ADDENDUM NO. 1

DATE: March 1, 2016
FROM: City of Grand Junction Purchasing Division
TO: All Offerors
RE: Mesa County Fairgrounds at Veteran's Memorial Park Grandstands Ramp Accessibility Project IFB-4182-16-DH

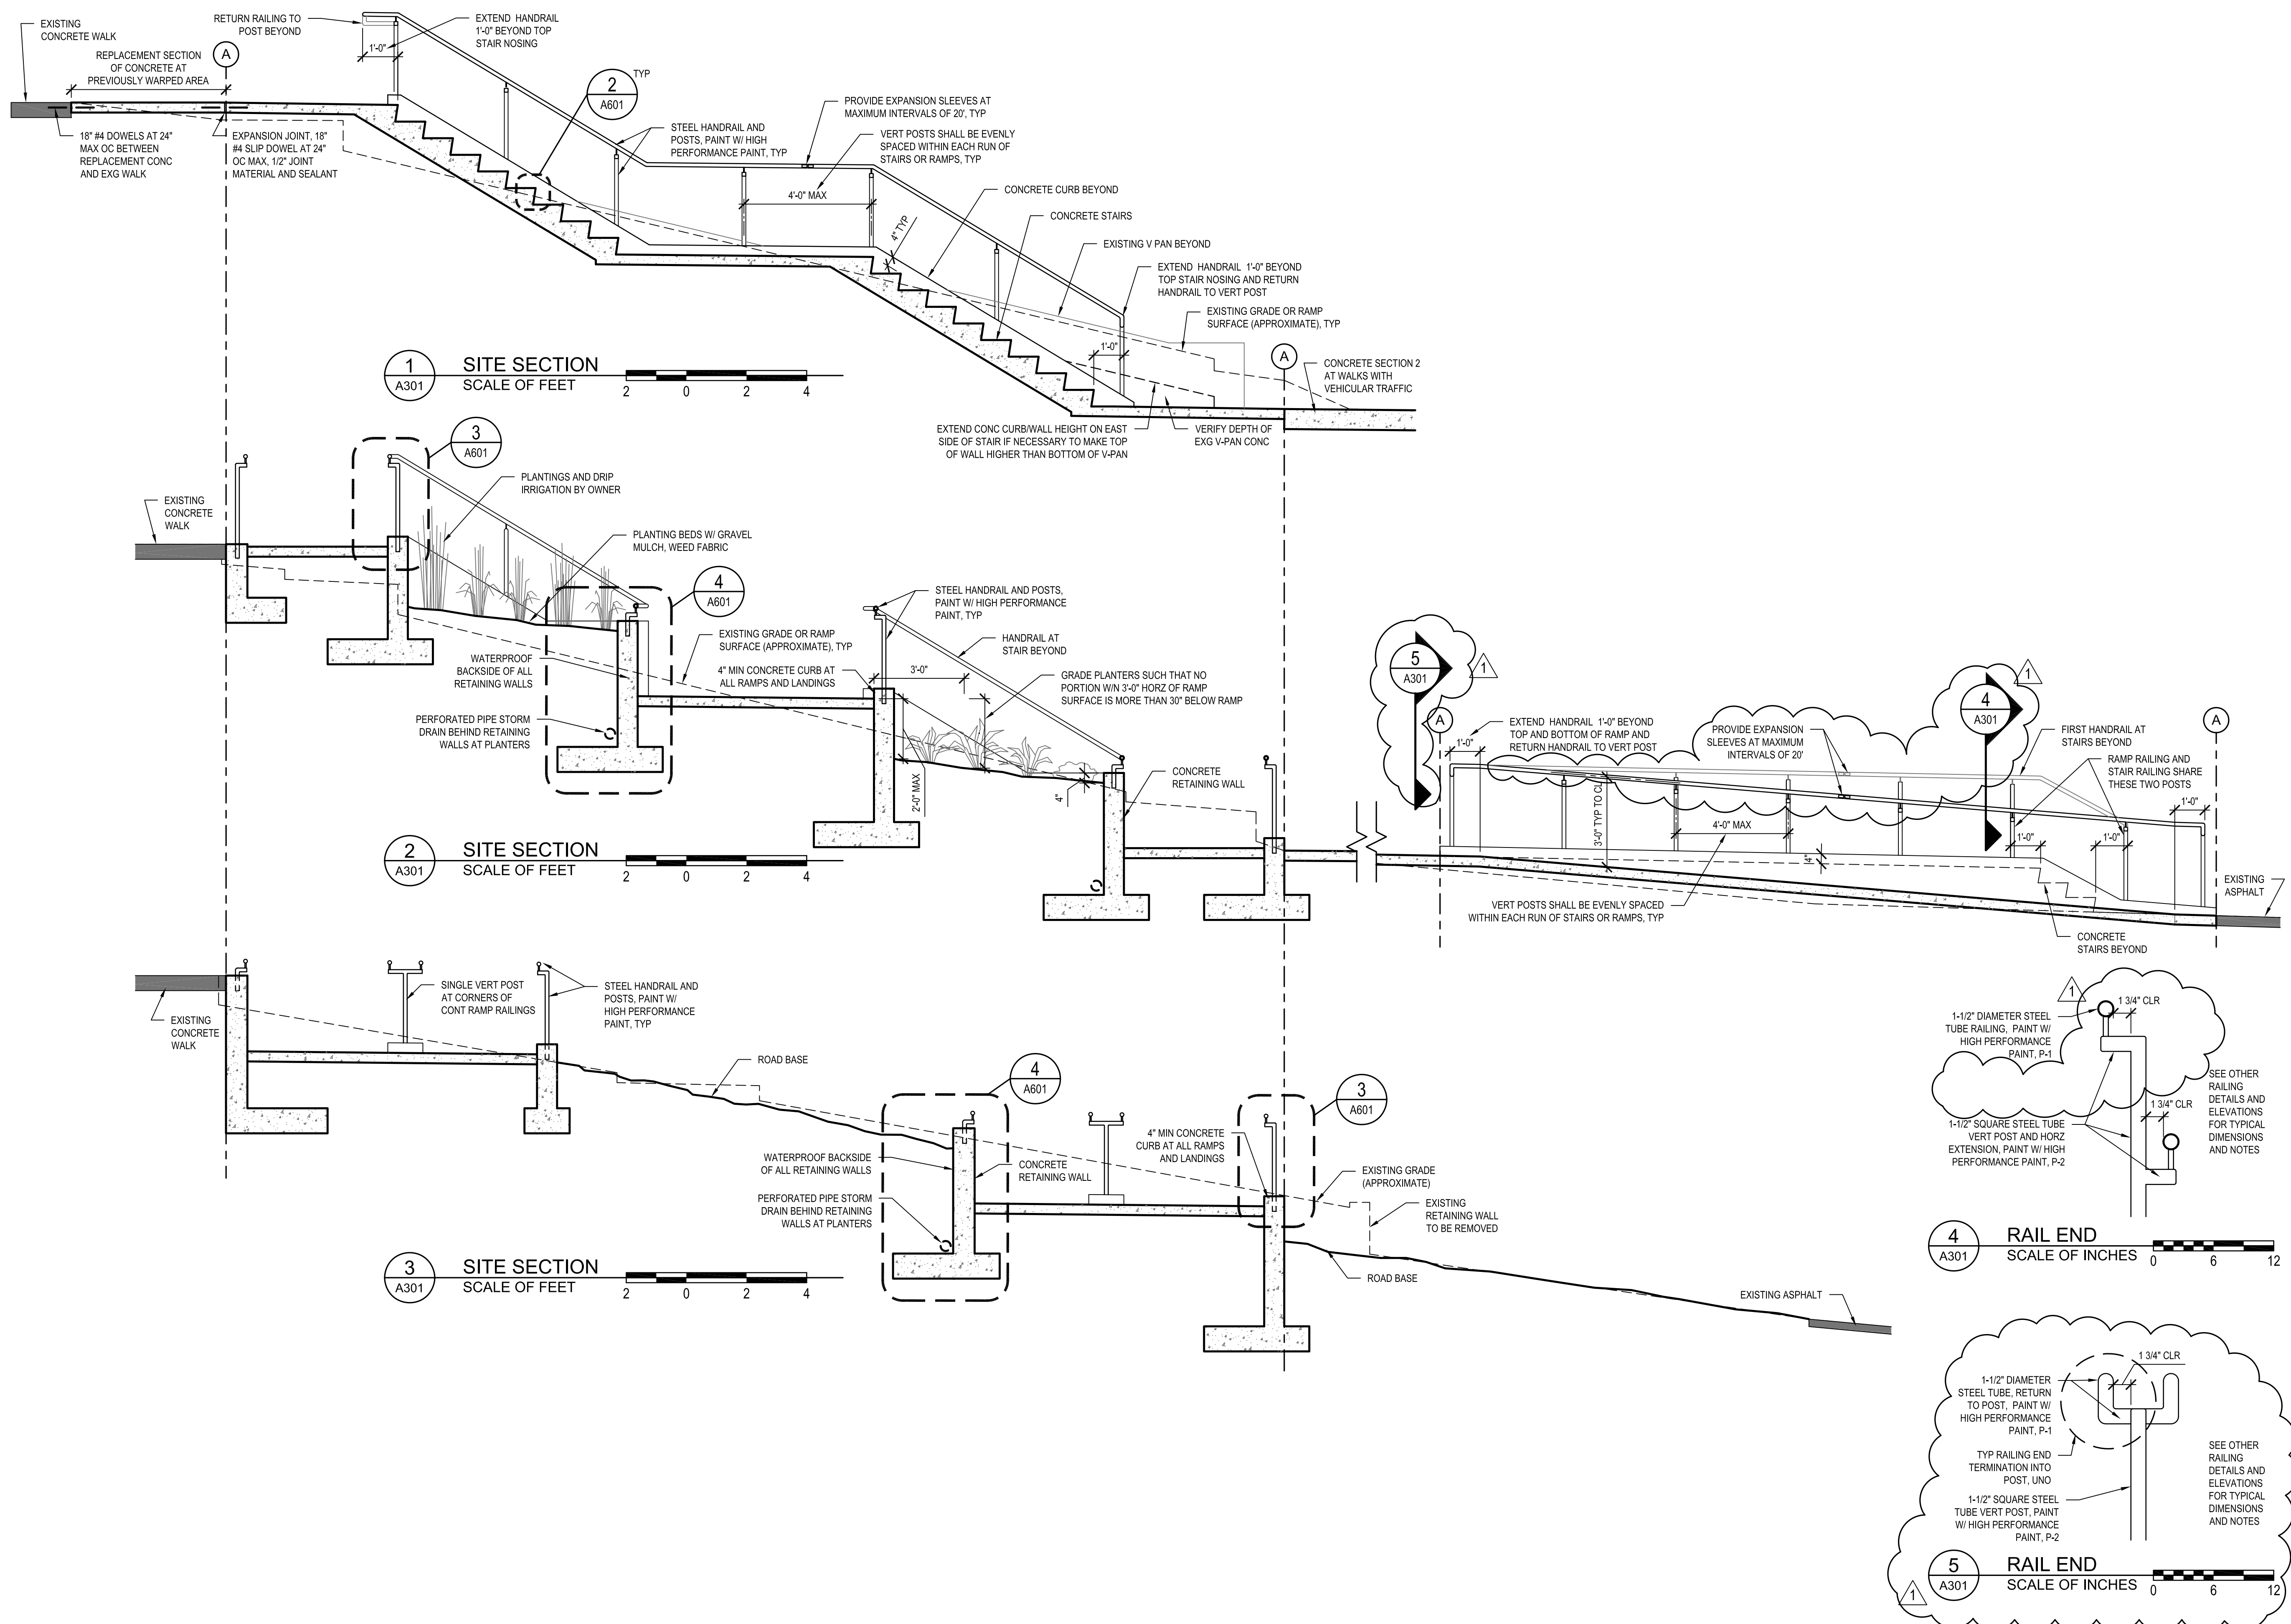
ADD1-7 Sheet A101: Modify storm drain routing and add cleanouts as indicated on attached sketch ASK-1.

SITE SECTIONS

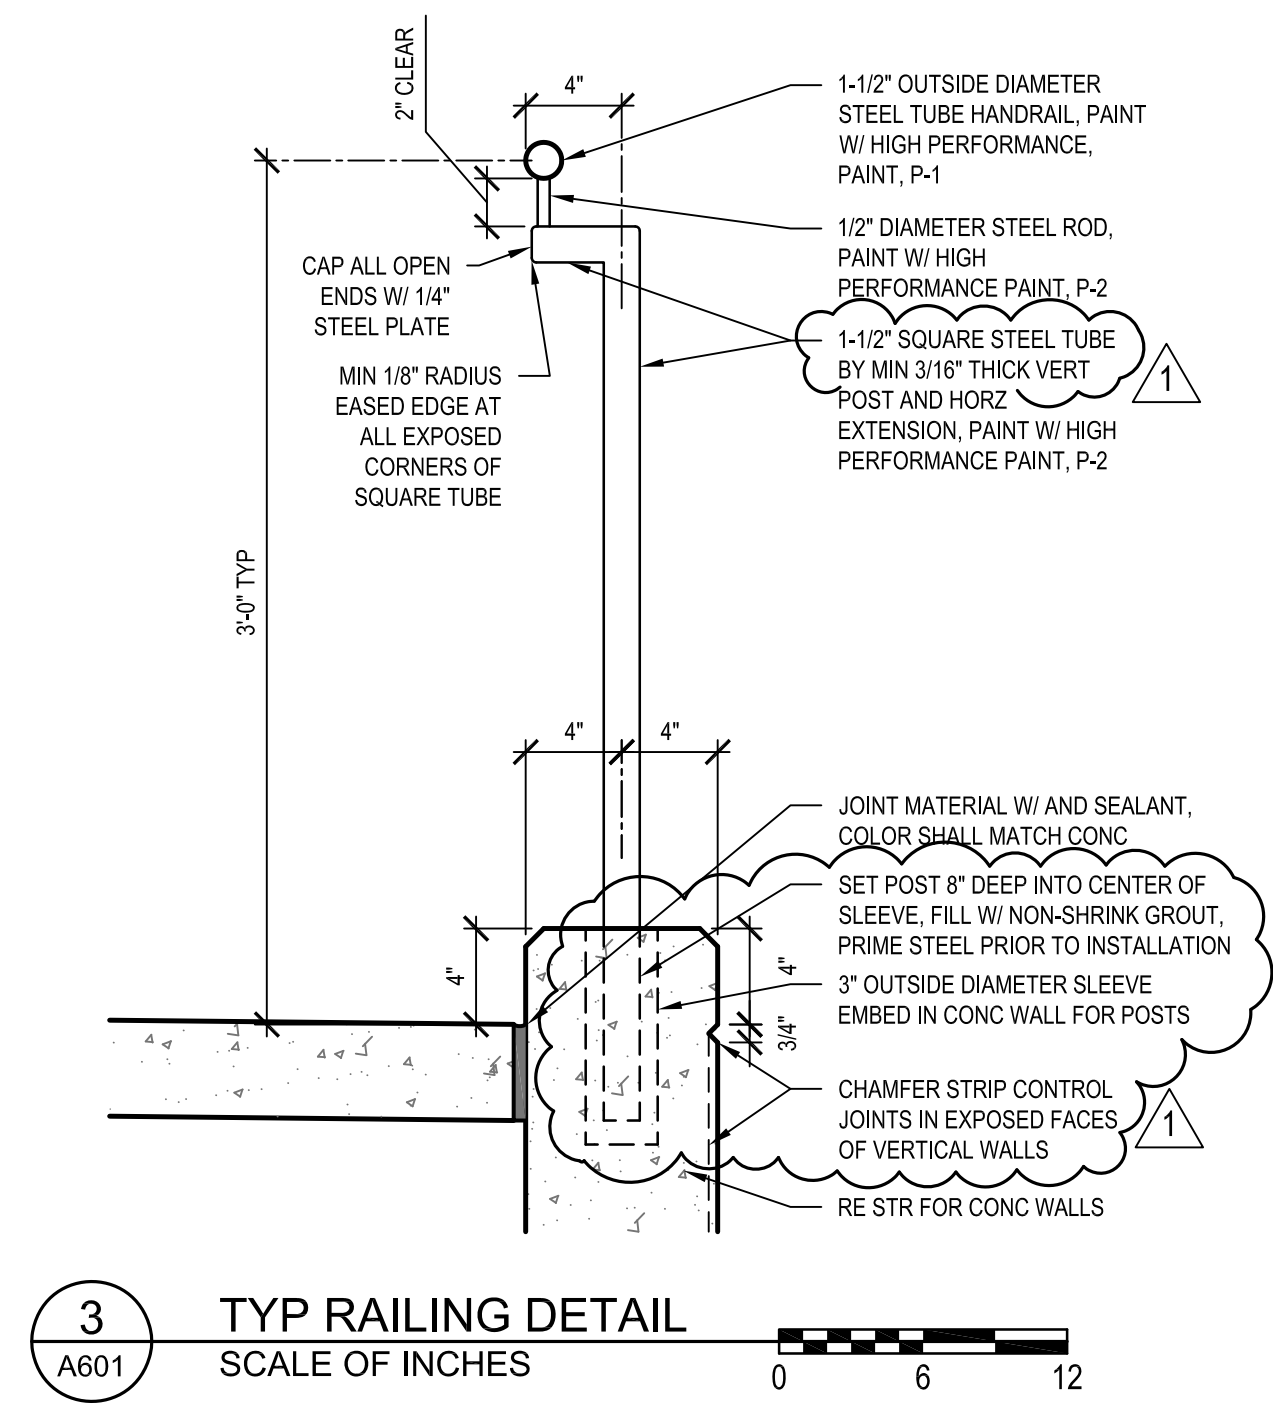
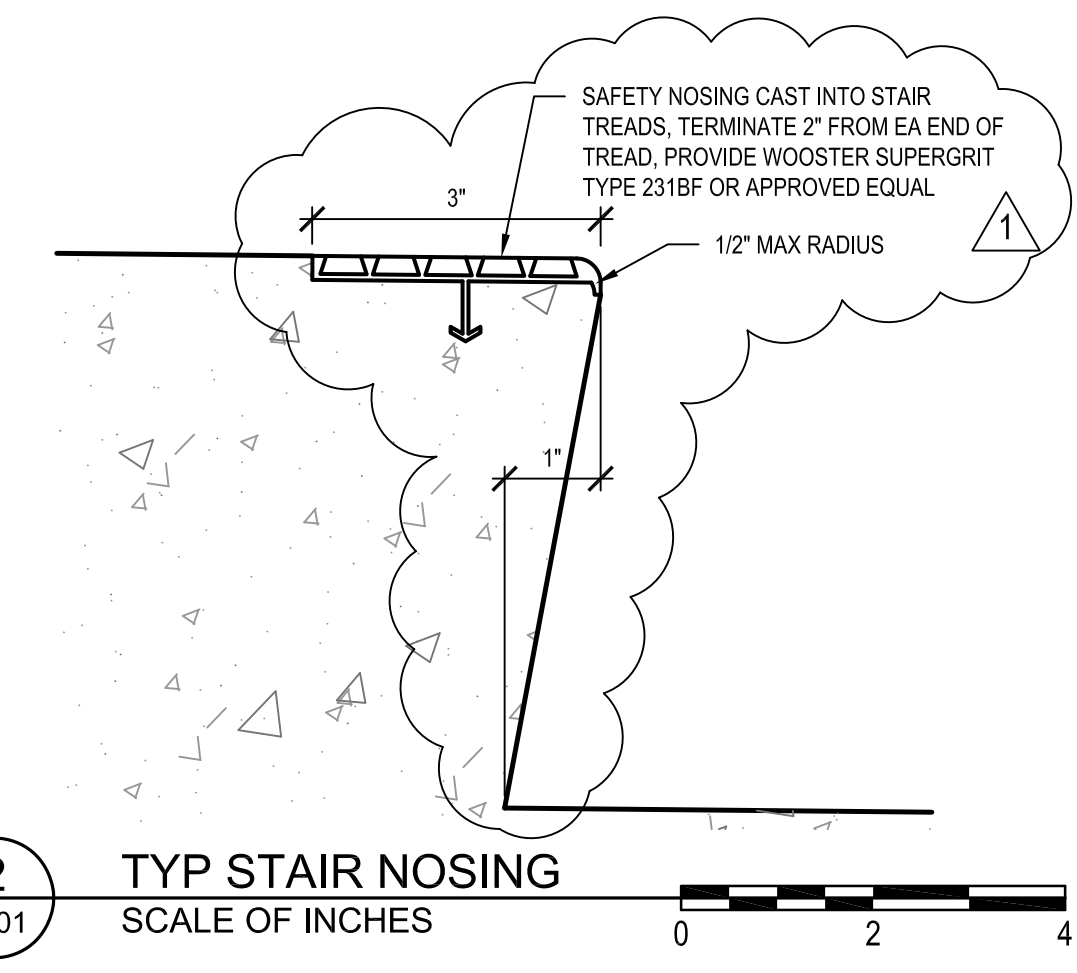
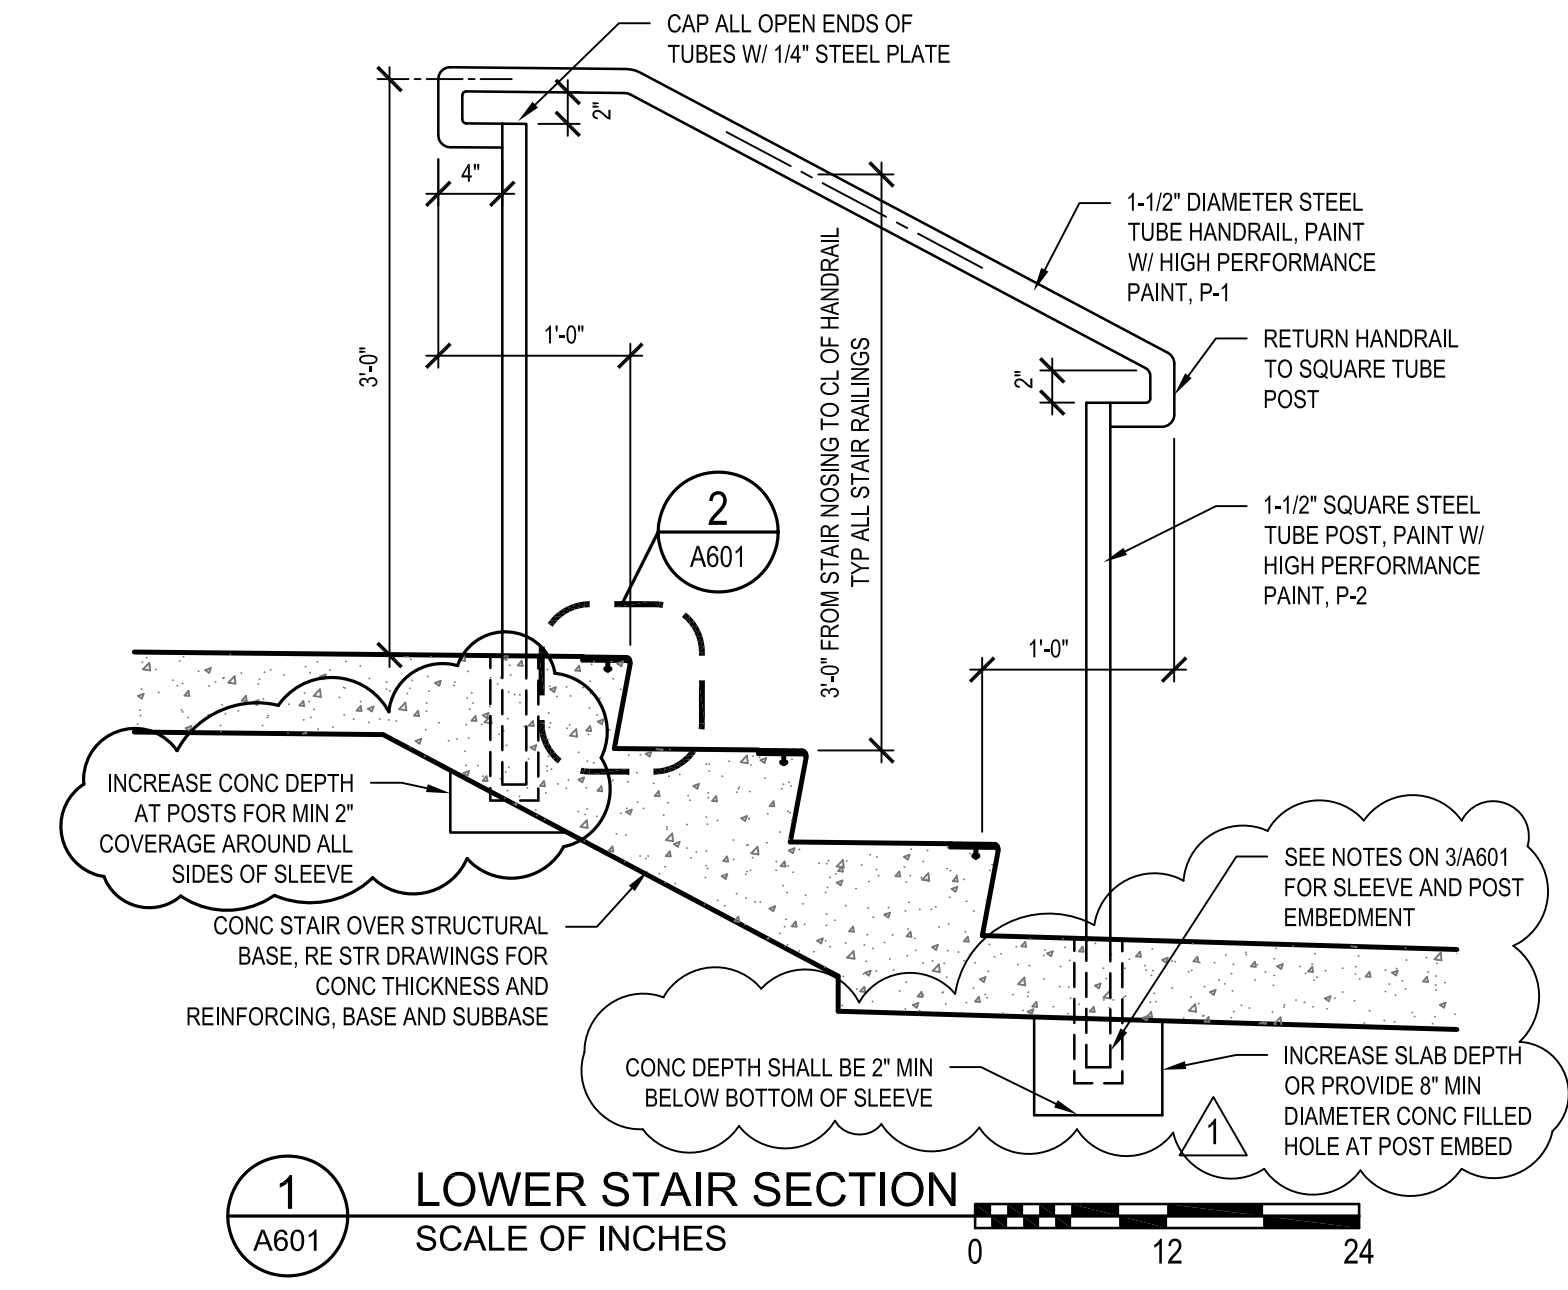
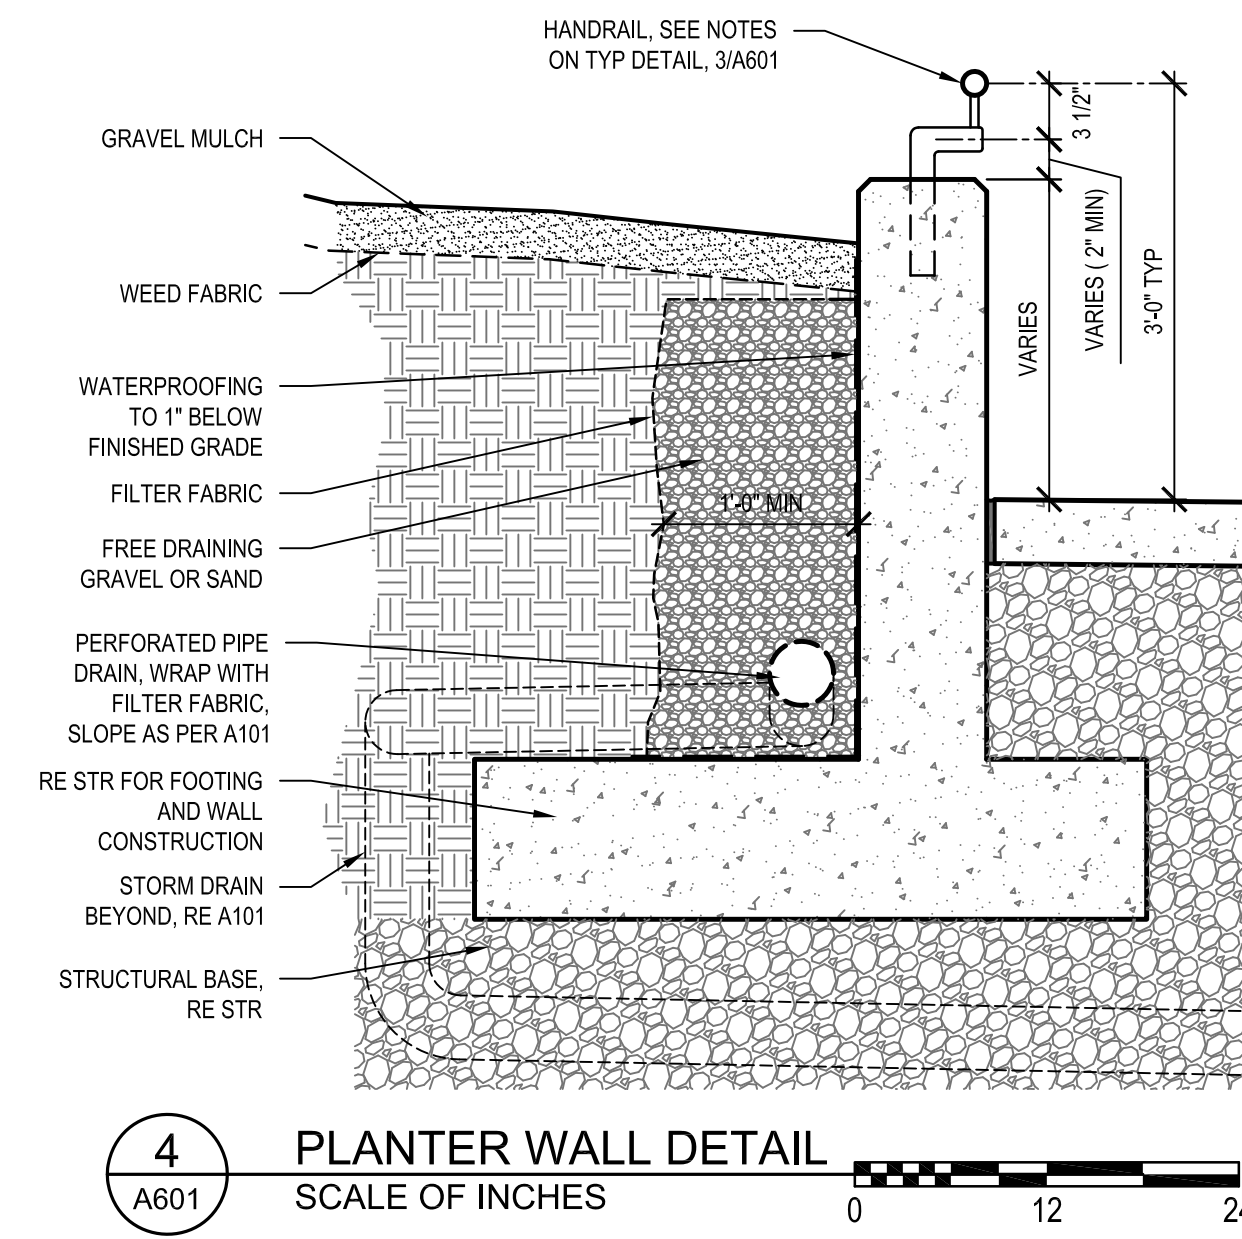
1. Q. On Section 2/A301, at the lower ramp, the handrail is shown to match the slope of the ramp which would put the top of the handrail less than 36" above the walkway to the stairs elevation. Shouldn't the handrail match the walkway grade to the top of the stairs for fall protection? If so, then a separate handrail will be needed for the ramp.

ADD1-9 Sheet A301, Site Sections: Modify details 1, 2 and 4, and add detail 5 per the attached reissued sheet A301.

- A. A separate rail will be added at the walk, see revised drawings.
2. Q. Detail 1/A601 - is the pipe for the rail offset from the posts to one side or is it in line with the posts? I assume in-line since traffic is on both sides but the detail makes it look like its offset.
